802.1Qbg VSI Discovery and Configuration State Machine

V12

August 17, 2010

- Tighten up the VDP state machine specification for the 802.1Qbg draft
- Retain existing VDP protocol

Expressing Bridge Resourcing States

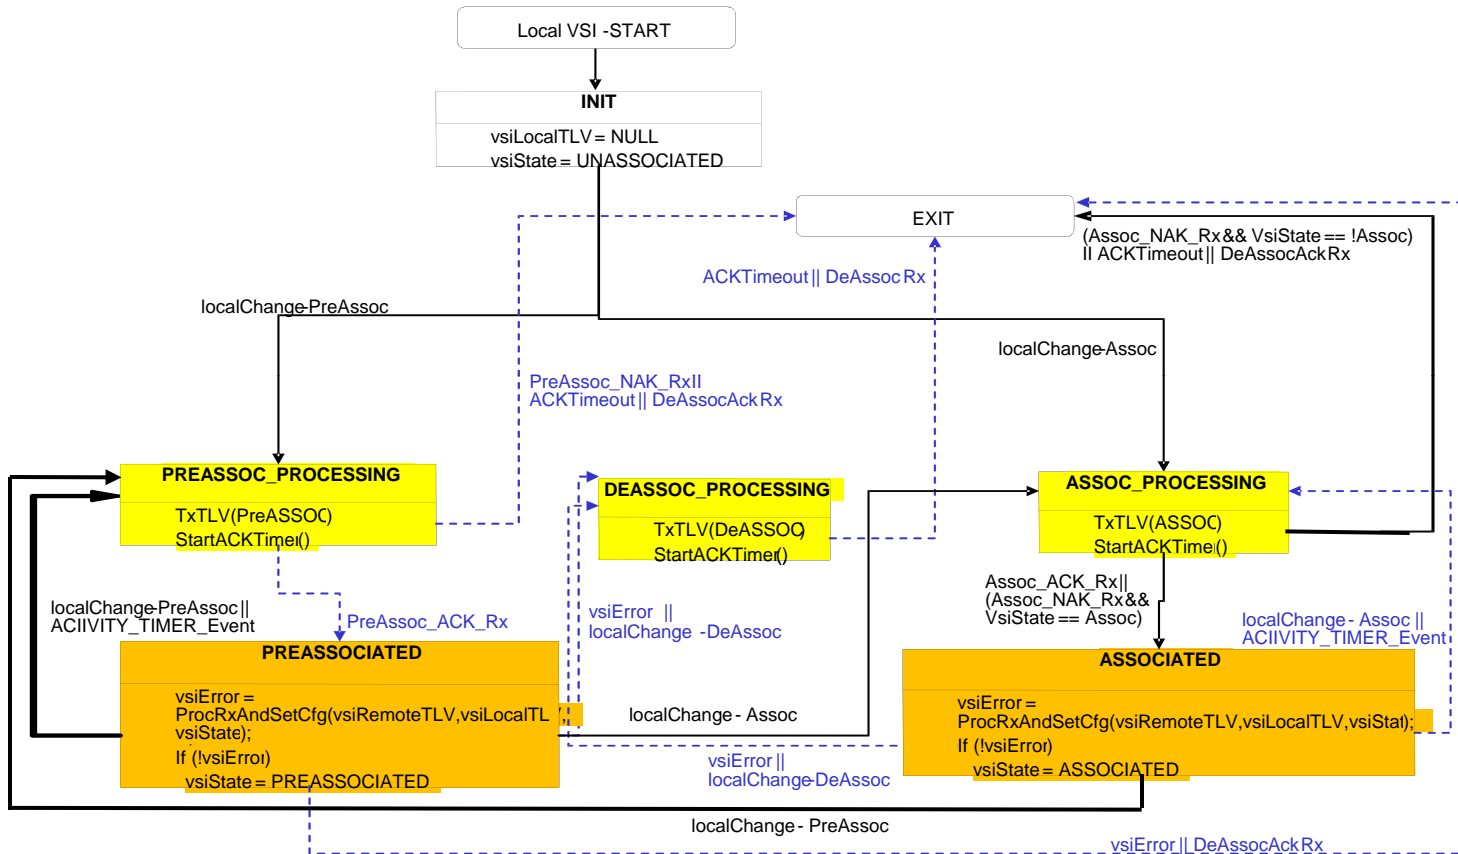
- Current state machine expresses the Bridge side resourcing request as a procedure hand-off.
- The bridge state machine hands the command to another machine which may query network management system before sending a response.
- It is convenient to break the command request into two states to allow time-out for the command hand-off
 - Need a timeout for the resource request from the Bridge
 - Need to build the response for the station from the resource request response

VDP Draft 1.0: State consolidation

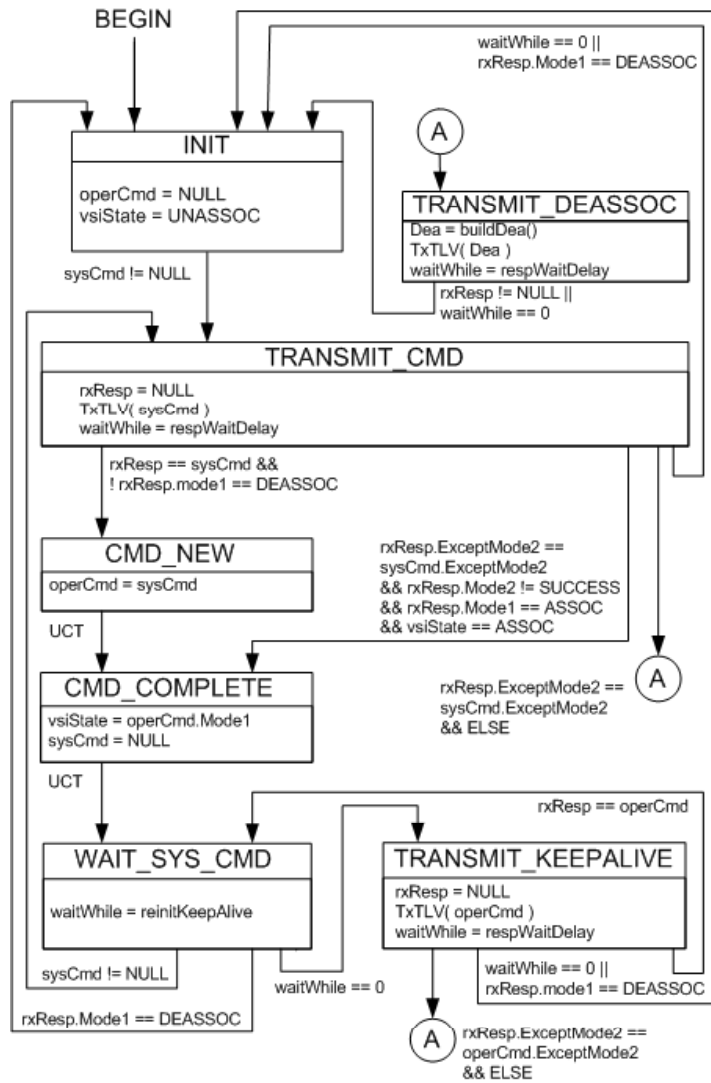
- Yellow states may be consolidated
- Orange states may be consolidated
